**AGENDA**  
CHARTER TOWNSHIP OF MERIDIAN  
ENVIRONMENTAL COMMISSION –  
REGULAR MEETING  
July 2, 2025 7:00 PM

**Re:** Wetland Use Permit #25-02 – Meridian Township Public Works – Construct a Boardwalk across a regulated wetlands along Bennett Road between the Schultz Veterinary Clinic and Bennett Woods Elementary

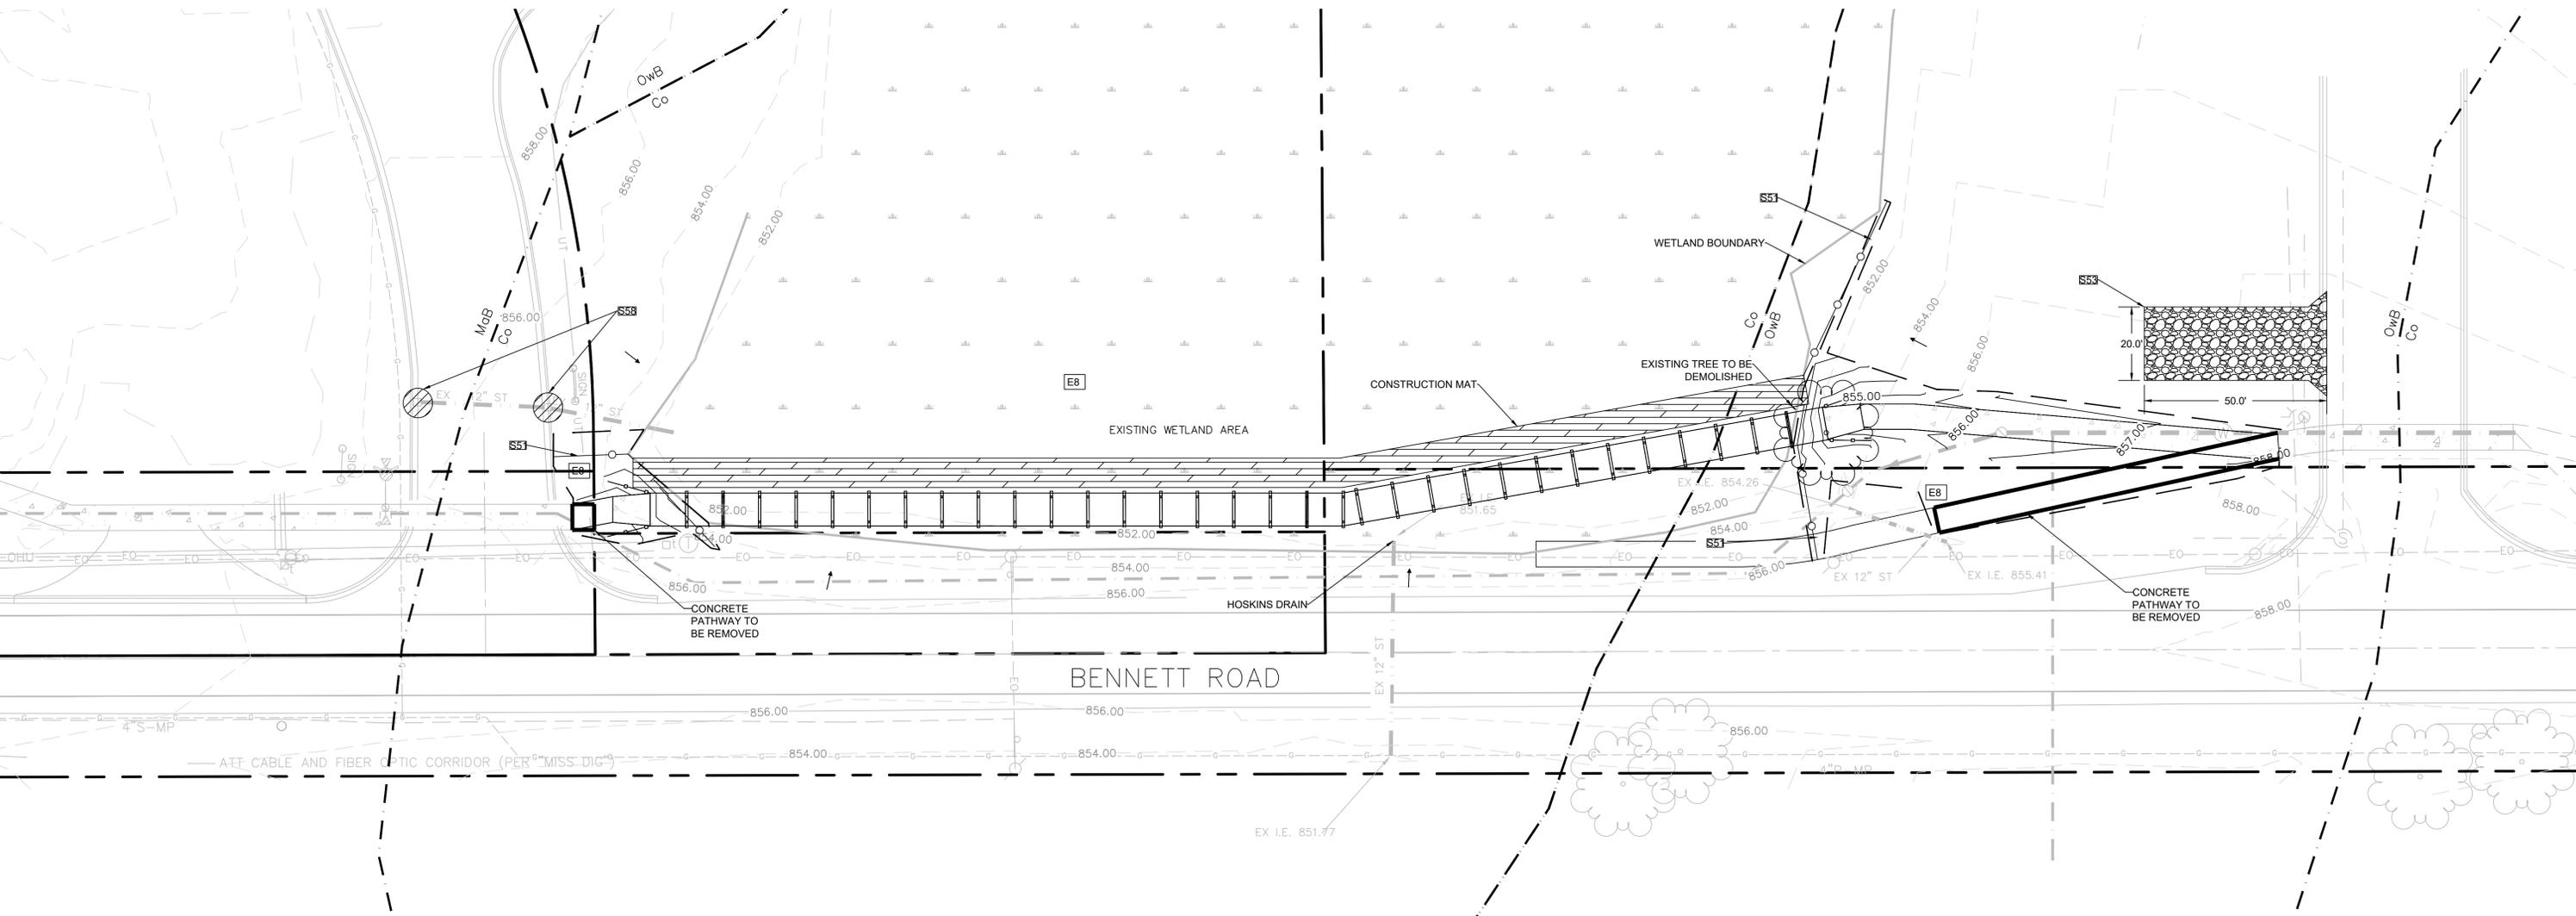
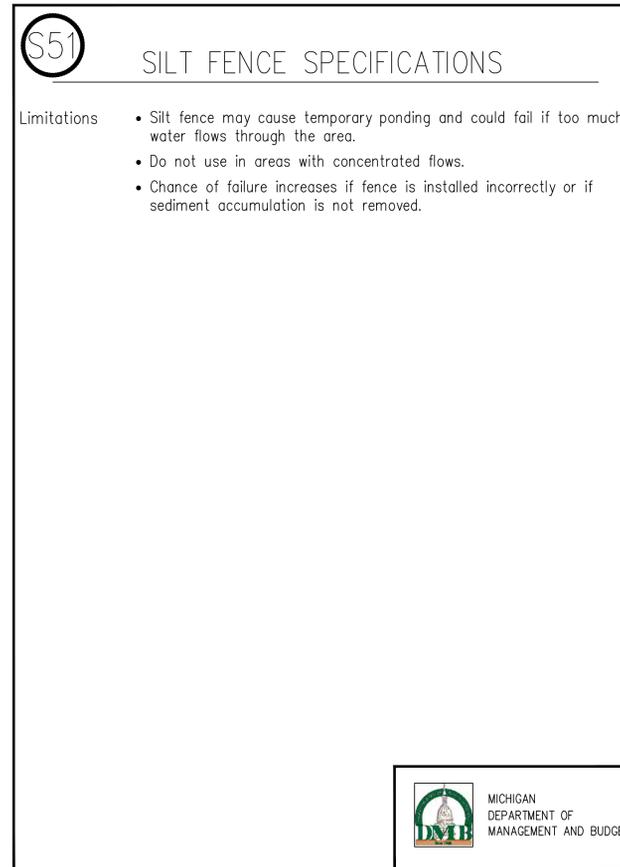
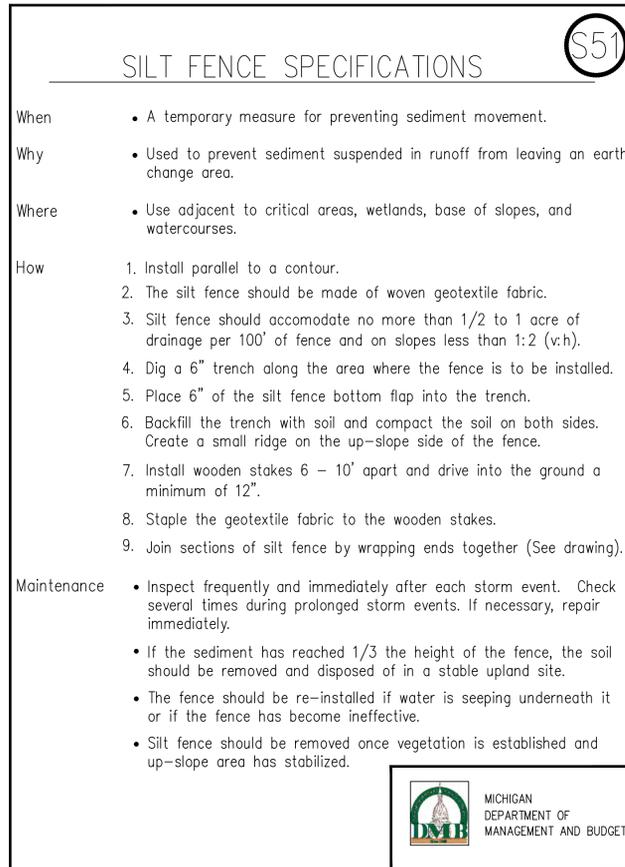
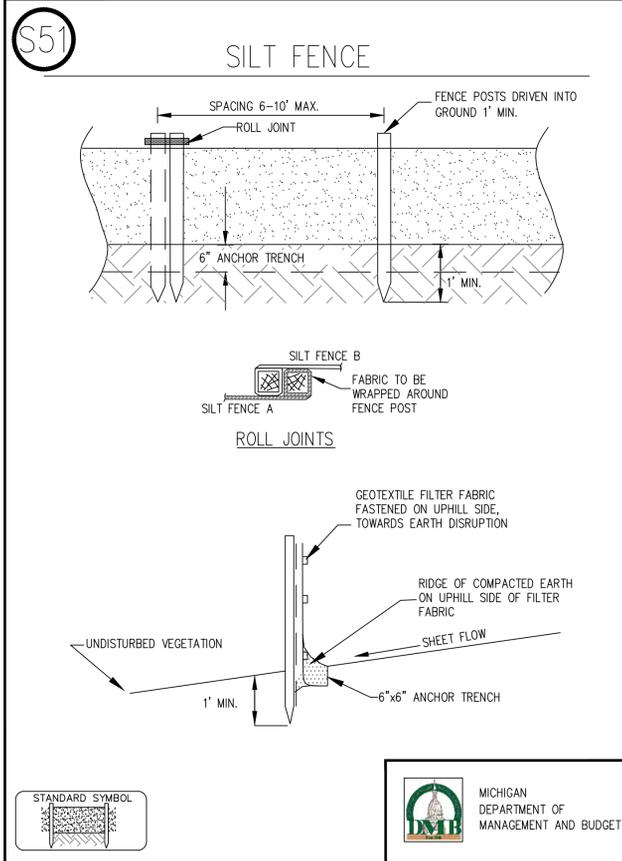
Clarify the following information in your construction sequence in MiEnviro:

- 1) The location of the construction entrance is shown on the SESC plan. Dimensions have been added to this plan, it will be 50' long by 20' wide. The material of the construction entrance will be 2-3 inch washed aggregate (stone or crushed concrete). The purpose is to prevent sediment from leaving the site and to provide a defined ingress/egress location for construction vehicles.

- 3) Rip rap is proposed around the outlet of Storm Pipe 3.
- 4) The existing 12" pipe that currently outfalls to the wetland will remain in place. We will propose a manhole structure at the end of it and propose a new 12" pipe on the north side (Storm Pipe 2) that will go through the proposed sheet pile retaining wall and outlet to the wetland. We are proposing to extend the existing 12" pipe so that we maintain the existing drainage pattern.

FRAMING PLAN

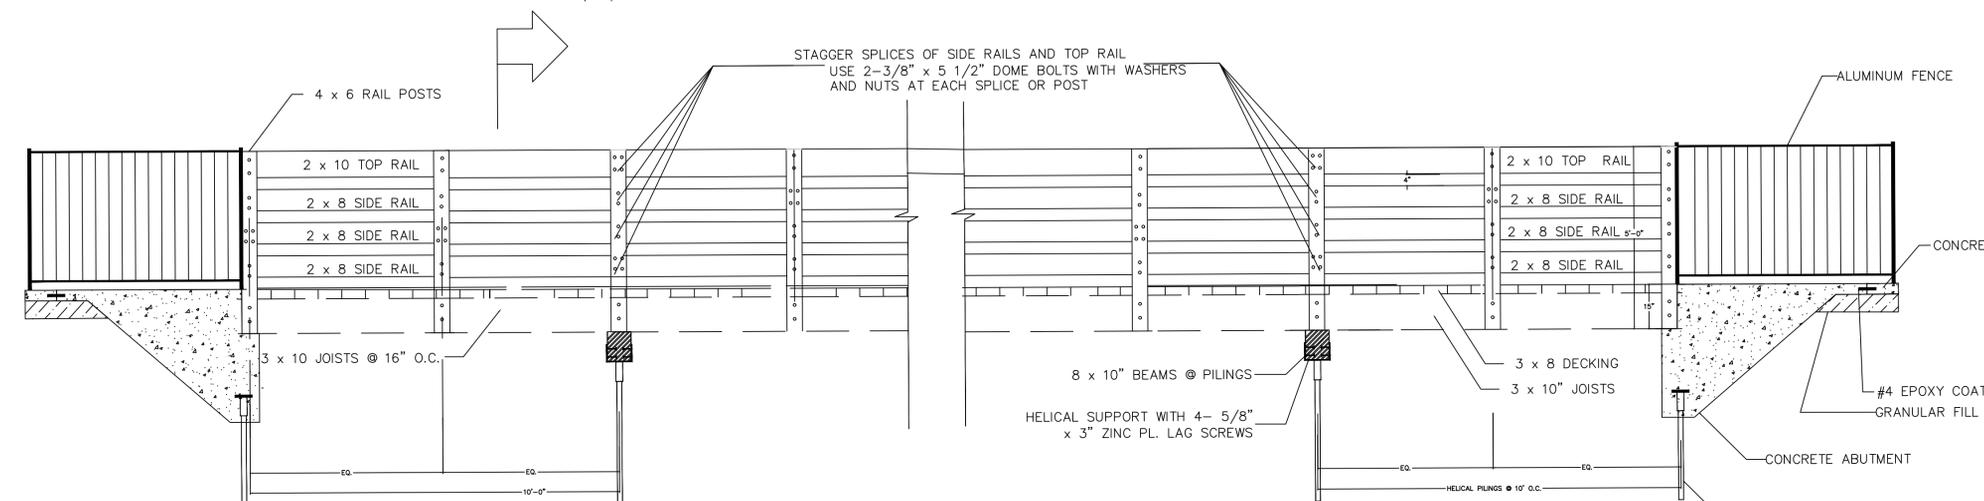
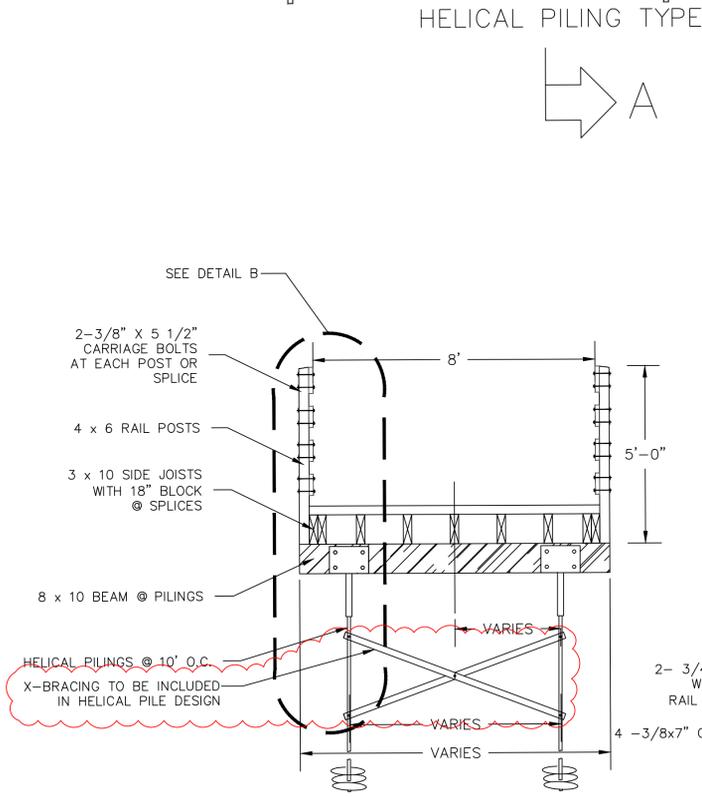
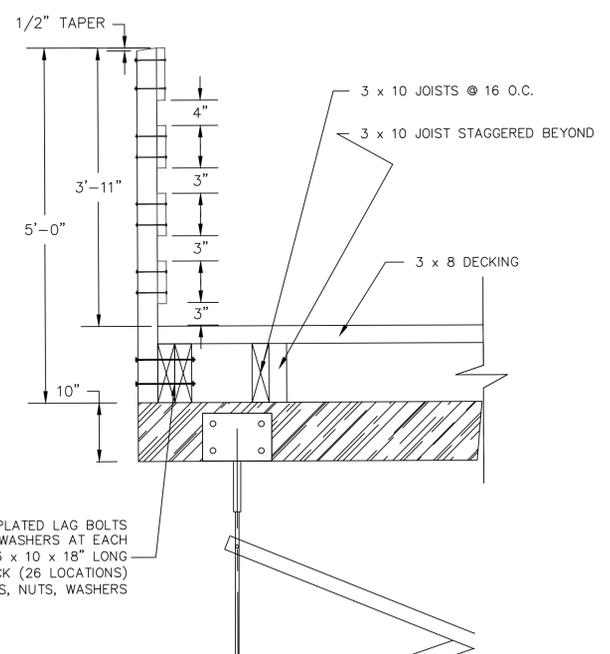
This project is close to meeting General Permit category requirements which is considered a feasible and prudent alternative if met. This would reduce impacts, time, and resources needed for the project. Please expand in the alternatives analysis why the boardwalk was the least impactful option for the project and provide more information for the following:

1. Is it possible to limit a section of boardwalk to 6 feet wide in some areas of the project? The GP category describes that widening the boardwalk for wheelchair passage is possible under this permit category at 150 foot increments. Please also provide ADA literature/guidance used to determine appropriate boardwalk width.
2. Please provide justification for railing usage for the proposed boardwalk.

1. Please see the revised alternatives analysis that explains why we can not use a 6' wide boardwalk for this project. I could not find any specific literature from ADA on boardwalks. However, I did find a document from Michigan DNR regarding the design of recreation facilities that exceeds ADA requirements. It mentions having a wider width boardwalk to allow for passing. This document can be found here <https://www.michigan.gov/dnr/-/media/Project/Websites/dnr/Documents/Grants/Spark/UniversalAccessibilityGuidance.pdf?rev=2b9410c9f84b4ab5af77d7f8f60b6865&hash=071D0E226053E93ED190FEFEE6C4D9B9>
